# UNITED STATES PATENT AND TRADEMARK OFFICE

APPLICATION NO.	FILING DATE	FIRST NAMED INVENTOR	ATTORNEY DOCKET NO.	CONFIRMATION NO.
09/209,751	12/11/1998	TORU MATAMA	1110-0212P	6573
7590 05/09/2005 BIRCH STEWART KOLASCH & BIRCH P O BOX 747 FALLS CHURCH, VA 22040			EXAMINER GENCO, BRIAN C	
			ART UNIT 2615	PAPER NUMBER
DATE MAILED: 05/09/2005

## Office Action Summary

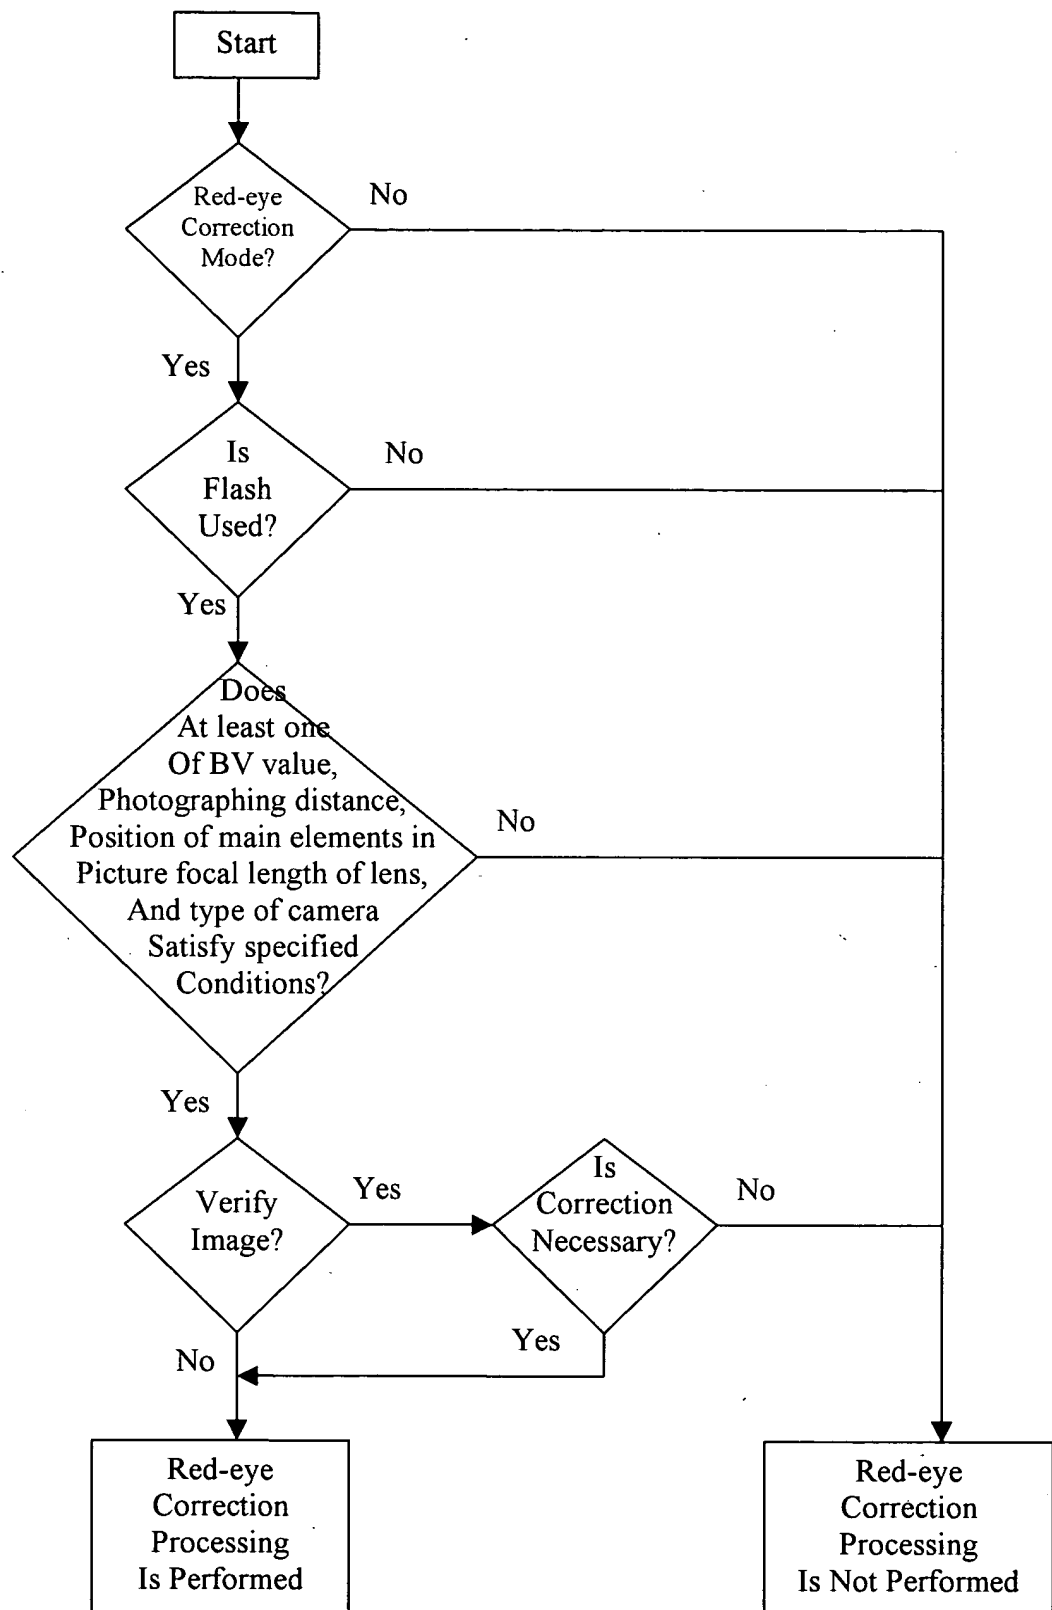
The last paragraph of page 12 is new matter corresponding to the branch of the flow diagram of newly added Fig. 3 leading to step S110 which is also new matter.

Examiner notes that the drawing objections were drawn to the limitations of claims 2-7 and 9 not being shown. Examiner agrees with the assertion that the limitations of claims 6, 7, and 9 were previously illustrated through Fig. 2. Examiner thanks applicant for adding Fig. 3 so as to show the limitations of claims 3-5 and a portion of claim 2. Examiner also thanks applicant for their effort in modifying Fig. 2 so as to show the other portion of the limitations of claim 2.

Examiner notes that the limitations of claim 2-5 are supported in the specification as originally filed on page 26, line 11 – page 27, line 7 wherein it is described that a means for selecting either one of execution and non-execution of processing as a mode is where a user can verify an image to determine if red eye correction processing is needed or where no verification or red eye processing is performed. On page 30, lines 11-15 it is described that either one of execution and non-execution of processing is selected as a mode. Finally on page 31, line 13 – page 32, line 11 it is described that either one of execution and non-execution of processing is determined automatically from photographing information.

As such, in order to overcome the drawing objections Examiner suggests modifying Fig. 3 as illustrated below corresponding to the disclosure of the specification as originally filed:

The drawings are objected to under 37 CFR 1.83(a). The drawings must show every feature of the invention specified in the claims. Therefore, the limitations of claim 2 must be shown or the feature(s) canceled from the claim(s). No new matter should be entered.
